Title
J-Link RX Adapter

Size A4 Number - Revision Rev. 5

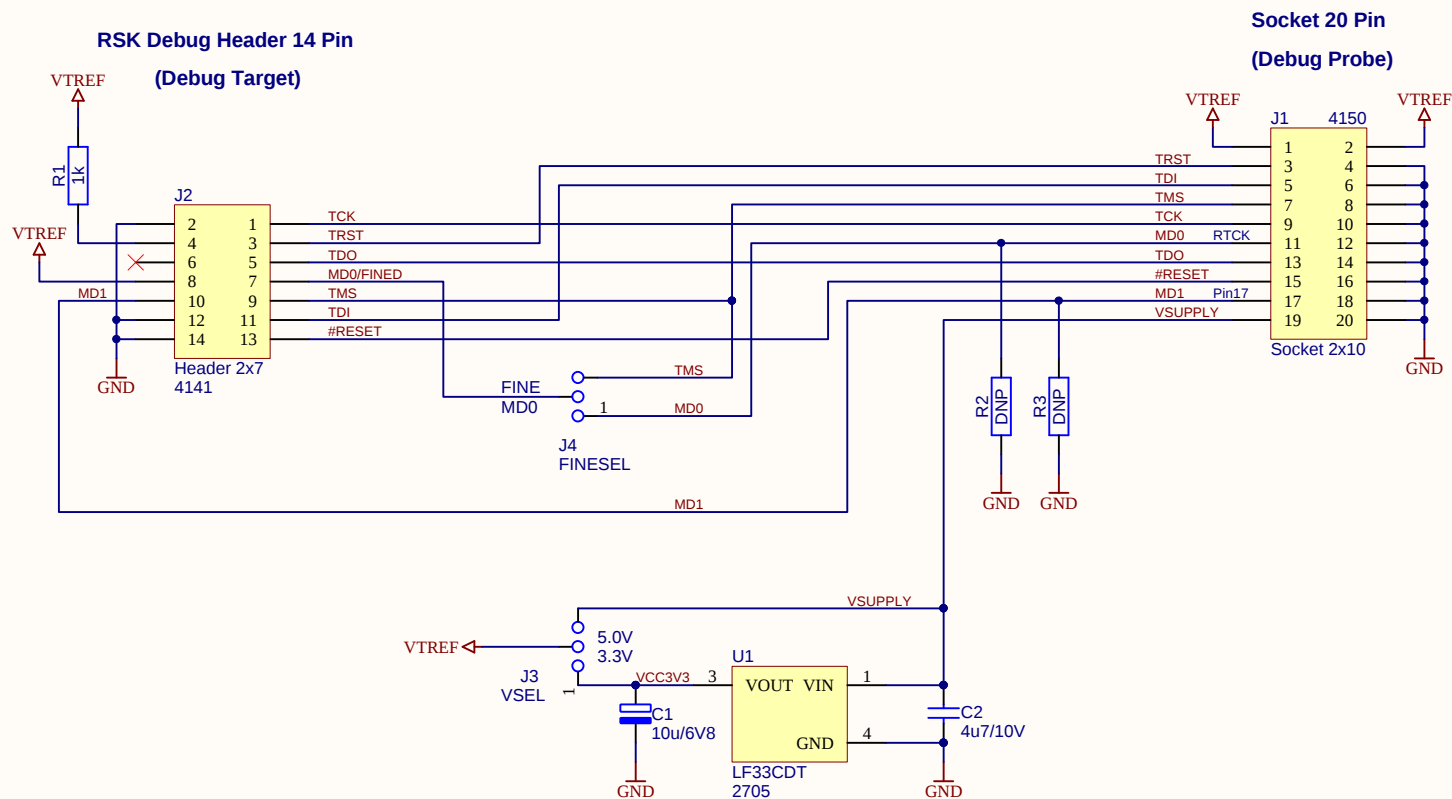
- Rev. 3:** J3 added to allow supply of target board
R1 added to pull EMLE high
- Rev. 4:** J3 modified to allow 2 different supply voltages
U1/C1/C2 added to support 3.3V supply
- Rev. 5:** Added signals MD0/FINED and MD1
Added Fine mode selection jumper J4
Added R2, R3 termination resistors (DNP) to avoid floating of RTCK/Pin17 inputs
